Proposal for a new 07 series of amendments to UN Regulation No. 48 (Installation of lighting and light-signalling devices)

Submitted by the Working Party on Lighting and Light-Signalling*

07 series of amendments to UN Regulation No. 48 (Installation of lighting and light-signalling devices)

Model A

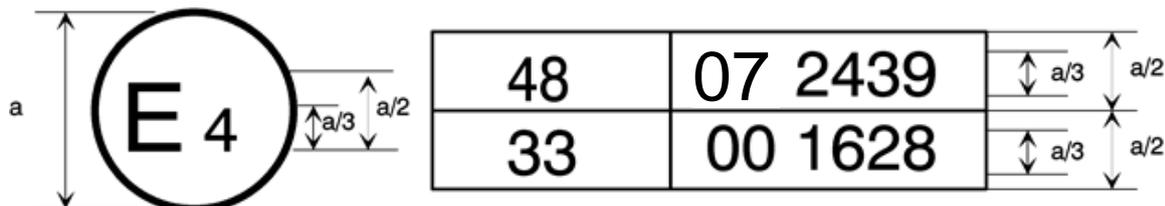
Annex 2, amend to read:

The above approval mark affixed to a vehicle shows that the vehicle type concerned has, with regard to the installation of lighting and light-signalling devices, been approved in the Netherlands (E 4) pursuant to UN Regulation No. 48 as amended by the 07 series of amendments. The approval number indicates that the approval was granted in accordance with the requirements of UN Regulation No. 48 as amended by the 07 series of amendments.
